METROPOLITAN GOVERNMENT OF NASHVILLE AND DAVIDSON COUNTY

STAFF RECOMMENDATION 1901 Fourth Avenue North July 16, 2014

Application: New construction—Infill and outbuilding; Setback determination

District: Salemtown Neighborhood Conservation Zoning Overlay

Figure 2. This 1957 Sanborn map shows that the house formerly on the site of 1901 4th Ave. N. (on the left) and the historic house across the street at 1900 4th Ave. N. (on the right) historically sat closer than ten feet (10') from the Coffee Street property lines.

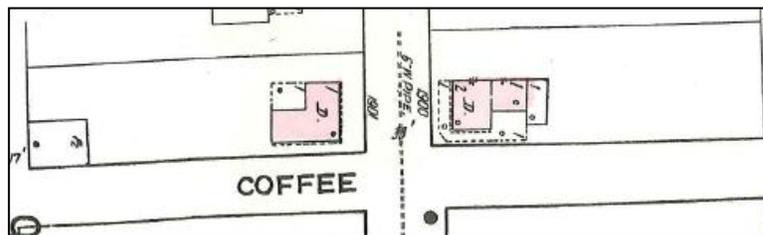
Setback & Rhythm of Spacing: The infill's front setback will match the front setback for the house next door at 1903 Fourth Avenue North, which is appropriate. The infill will be five feet, three inches (5'3") from the north side property line, and more than seventy feet (70') from the rear property line, meeting the base zoning requirements for setbacks. However, the infill requires a setback determination for its side setback from Coffee Street. Base zoning requires that on corner lots, primary structures be located ten feet (10') from the side street property line. The bulk of the infill will meet the ten foot (10') setback, but the porch and the first story bay will intrude on the setback. The porch will be five feet, six inches (5'6") from the Coffee Street property line, and the first story bay will be eight feet, six inches (8'6") from Coffee Street property line. Staff finds the proposed setback for the Coffee Street property line to be appropriate for several reasons. The main portion of the house will meet the side setbacks, and it is only minor

façade elements that intrude on the setback. The bay and the wrap-around porch help to break up the Coffee Street façade and add architectural interest to this highly visible part of the infill. Moreover, an analysis of the corner lots nearby show that the historic structures, including the two-story structure across the street at 1900 Fourth Avenue North, are situated less than ten feet (10') from the Coffee Street property line. The 1957 Sanborn Map also indicates that the house formerly on this lot was situated less than ten feet (10') from the Coffee Street property line (Figure 2). For these reasons, staff finds that the proposed reduced Coffee Street property line setback meets the design guidelines, and that the infill meets Section III.C. of the *Salemtown Neighborhood Conservation Zoning Overlay: Handbook and Design Guidelines*.

SITE PLAN

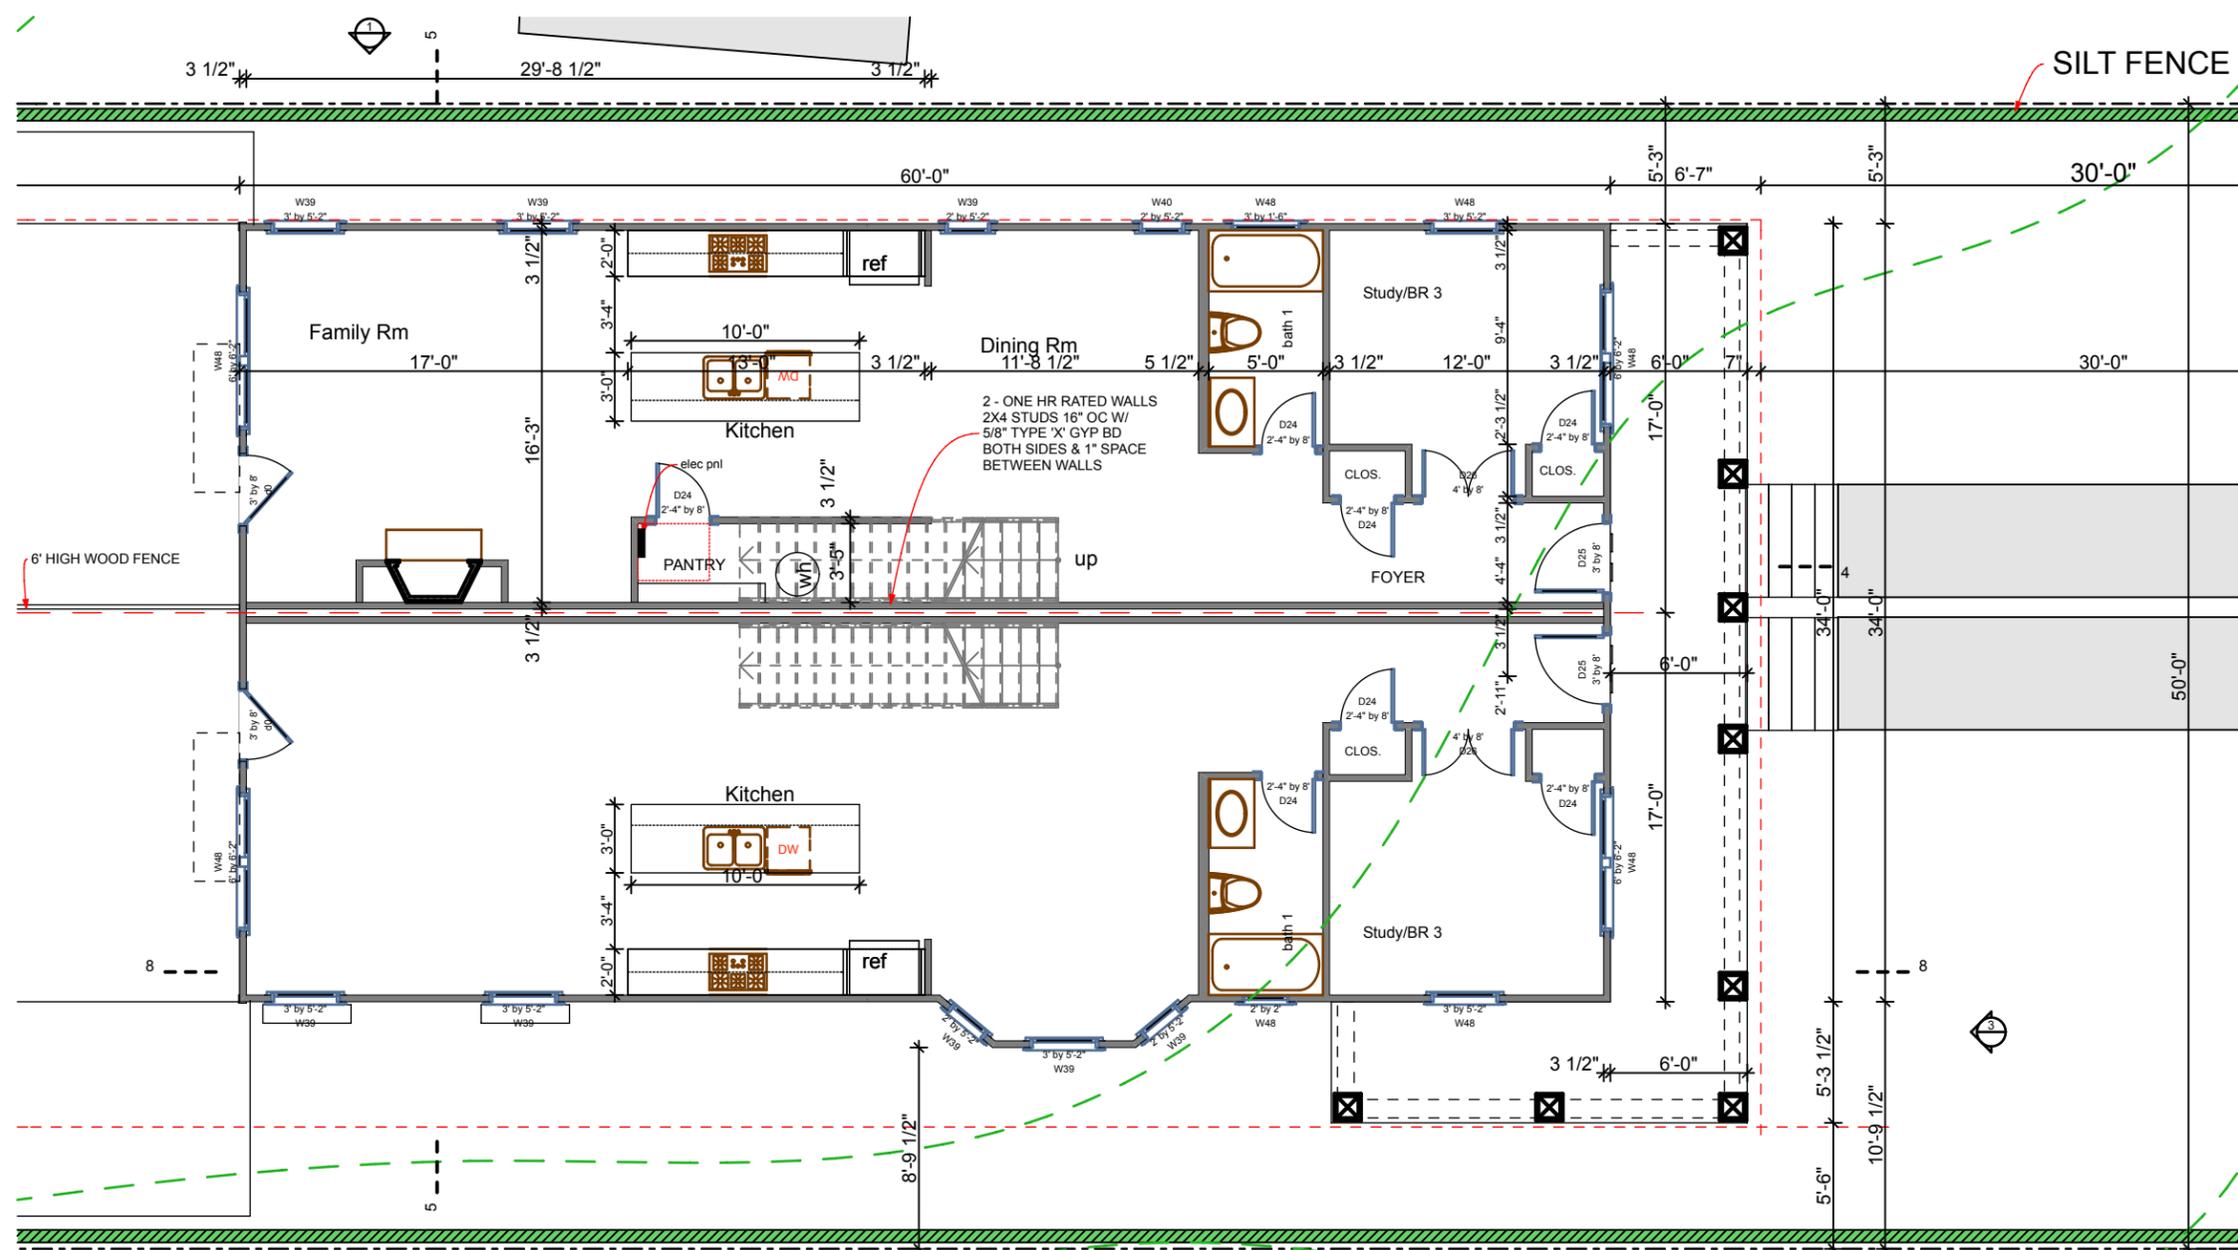
The proposed carport requires setback determinations for all three of its setbacks. Because the outbuilding is located on a corner lot, and is more than seven hundred square feet (700 sq. ft.), base zoning requires that it be ten feet (10') from the Coffee Street property line, five feet (5') from the interior lot property line, and twenty feet (20') from the rear property line. The applicant is proposing to locate the outbuilding five feet, six inches (5'6") from the Coffee Street property line, four feet, seven inches (4'7") from the interior lot property line, and ten feet (10') from the rear property line. Staff finds the proposed setbacks to be appropriate because historically outbuildings sat close to or on the rear and side property lines. In fact, the 1957 Sanborn Map shows that an outbuilding on this property formerly sat on both the Coffee Street and the rear property lines. Staff finds that the proposed setbacks are appropriate to the *Salemtown Neighborhood Conservation Zoning Overlay*.

CARPORT ELEV.

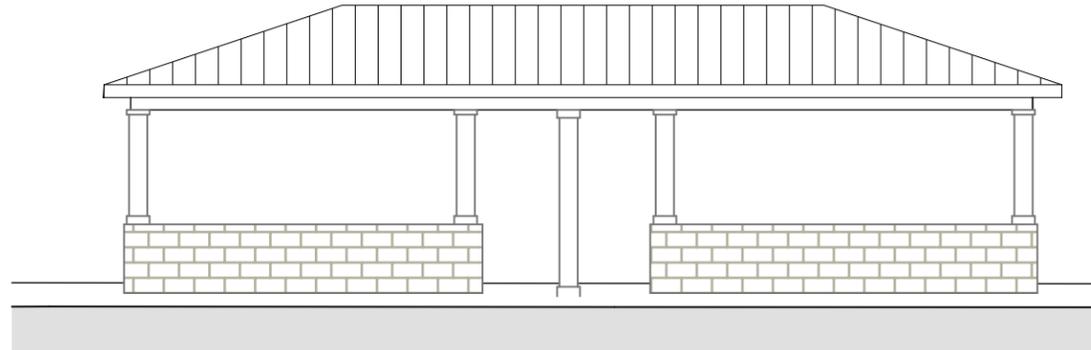
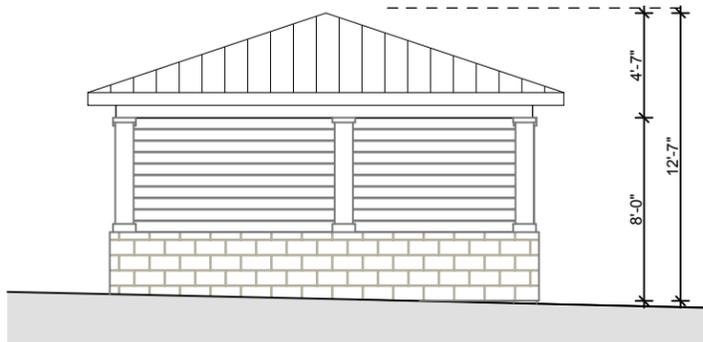
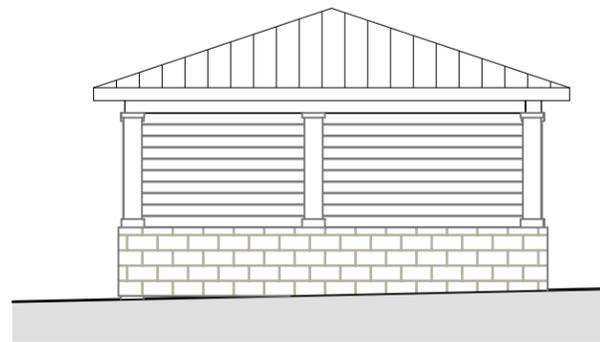
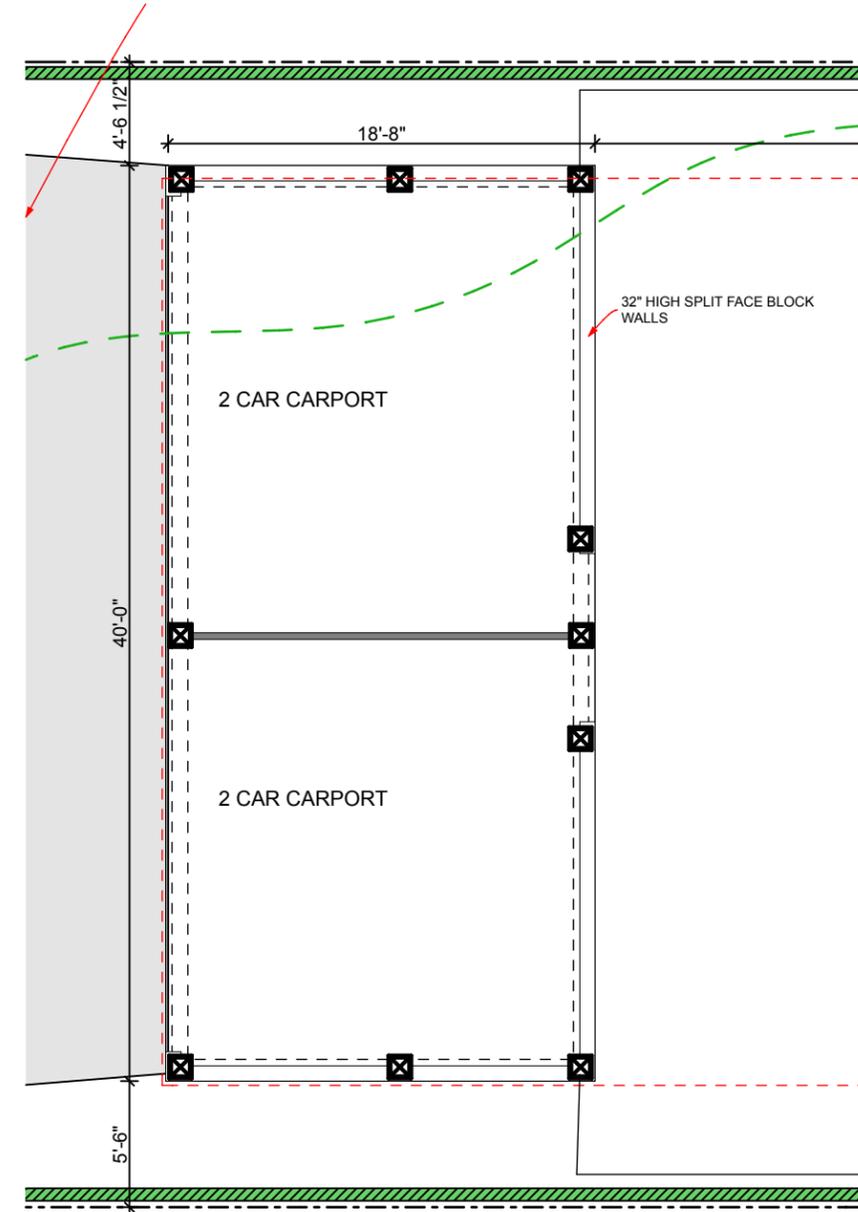
Outbuildings: The applicant is proposing a one-story, four-car carport that is eighteen feet, eight inches (18'8") deep and forty feet (40') wide, or approximately seven hundred and forty-seven square feet (747 sq. ft.). The carport will have an eave height of approximately eight feet (8') and a ridge height of approximately twelve feet, seven inches (12'7"). The Commission has rejected requests for four-bay garages and carports behind duplexes in the past. Staff therefore recommends that the applicant redesign the one-story carport so that it has just two bays or so that there are two separate carports that are one bay each. The two bay carport or the two, one bay carports could have uncovered parking pads adjacent to them to provide for additional parking.

The outbuilding will have a hipped roof form with a slope of approximately 6/12. It will be accessed via the alley, which is appropriate. The materials will be similar to those on the new infill. It will have a split face concrete block foundation, wood columns, and a standing seam metal roof.

Staff asks that the four-car carport be changed to be either a one-story, two-bay carport or two, one-story, one-bay carports, with or without adjacent uncovered parking pads, in order for it to meet Section III.H. of the *Salemtown Neighborhood Conservation Zoning Overlay: Handbook and Design Guidelines*.
